**ANNOTATED
AGENDA
CITY OF ANTIOCH PLANNING COMMISSION
ANTIOCH COUNCIL CHAMBERS
THIRD & "H" STREETS**

WEDNESDAY, AUGUST 19, 2015

**STAFF REPORT TO THE PLANNING COMMISSION
FOR CONSIDERATION AT THE MEETING OF AUGUST 19, 2015**

APN 052-140-002
SHEET NO. 3
OF 4 SHEETS
JOB NO. 14-14-01

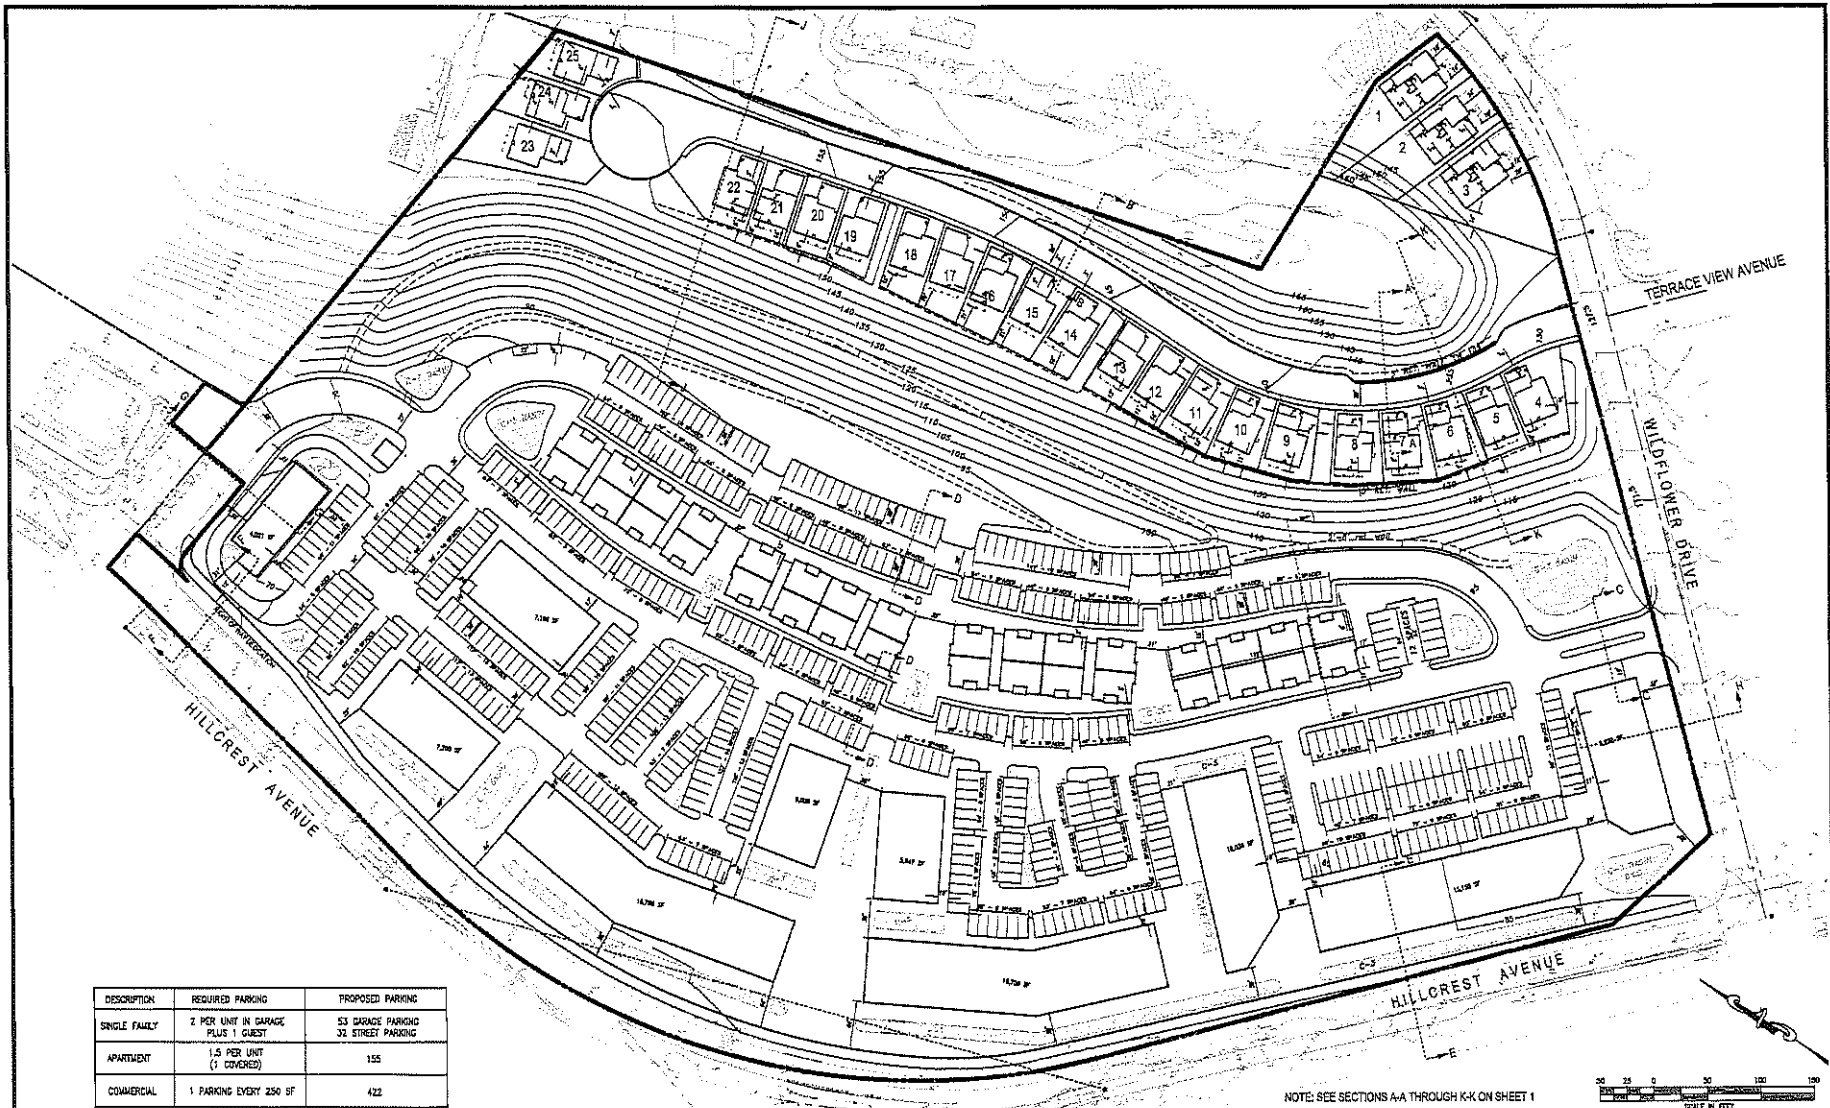
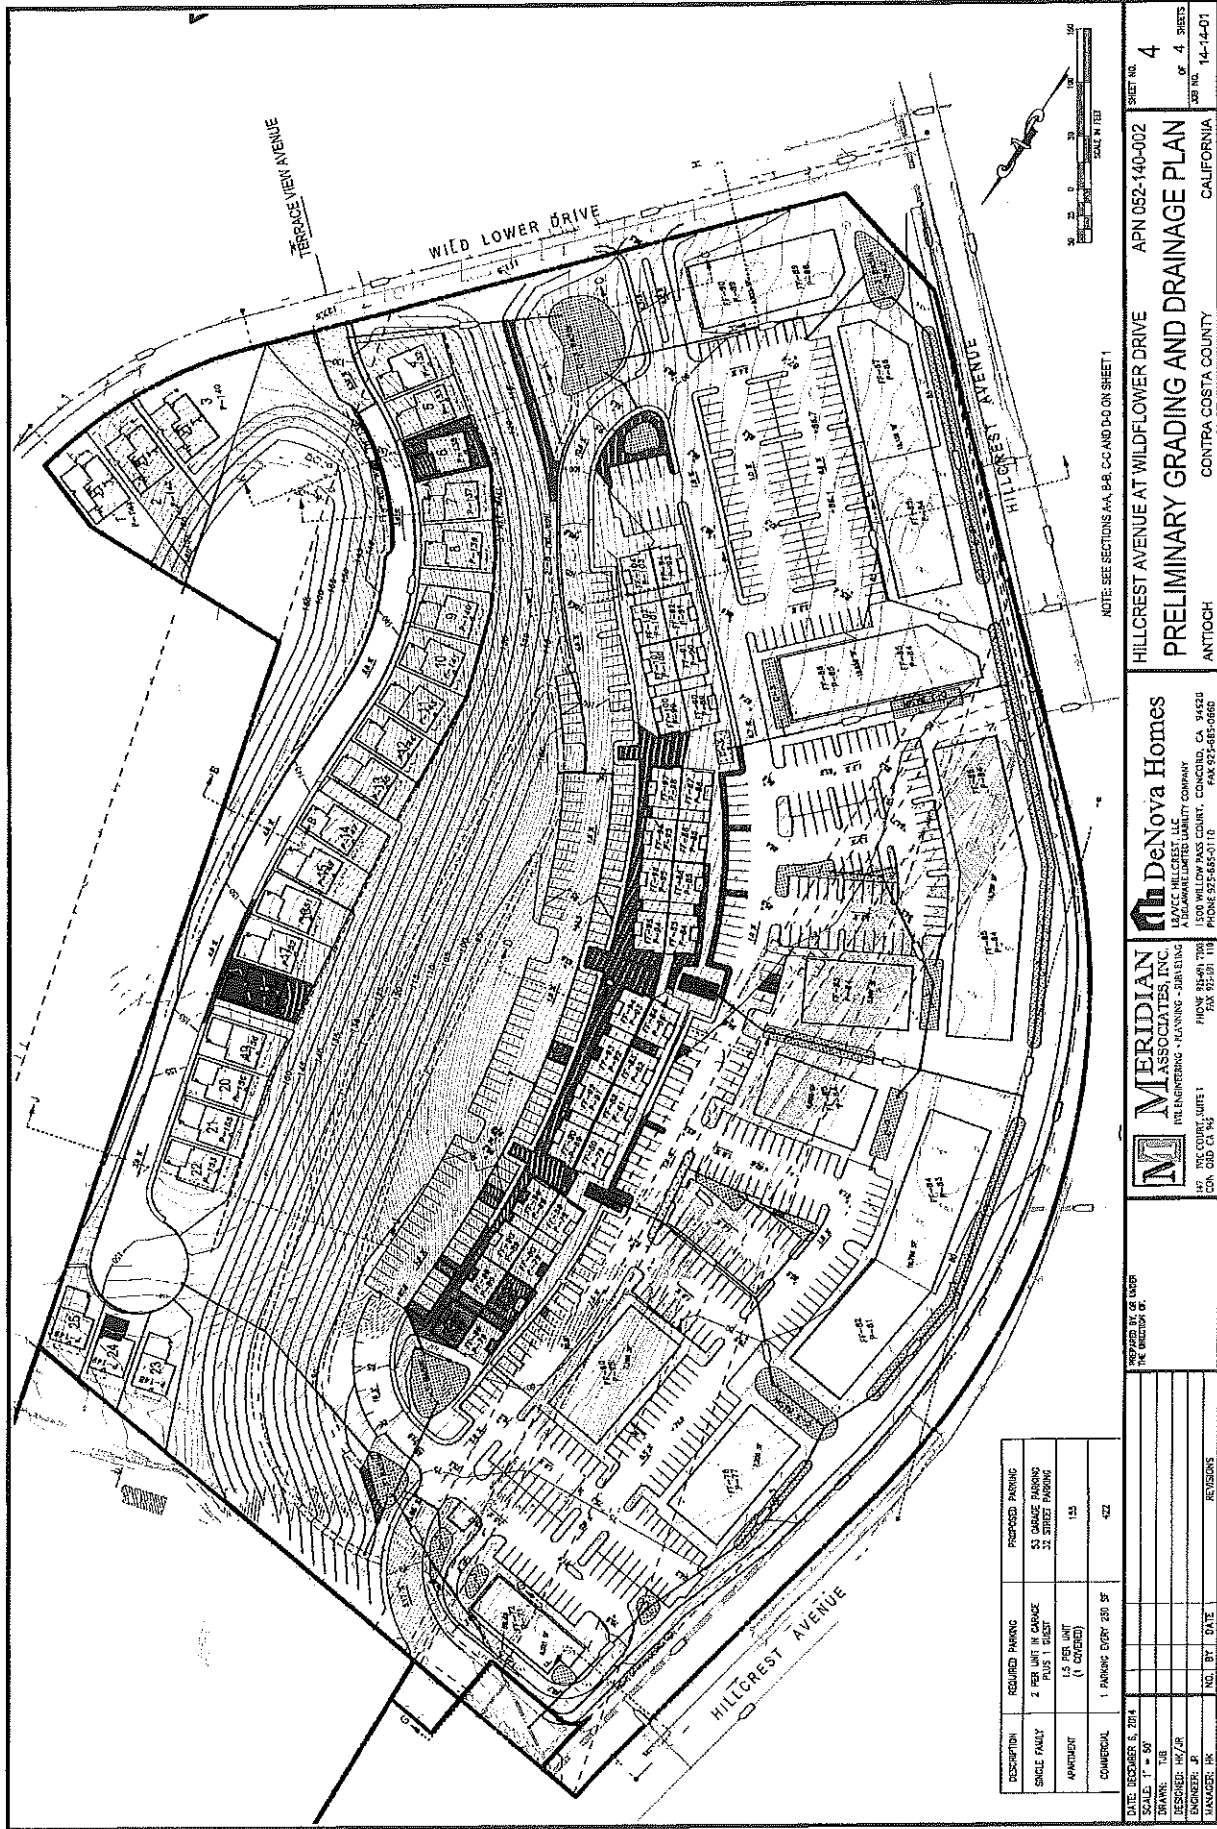
- c. The parking table provided on Sheet 4 states that there will be 32 on-street parking spaces. Please provide a parking plan identifying where each of those 32 parking spaces will be located.
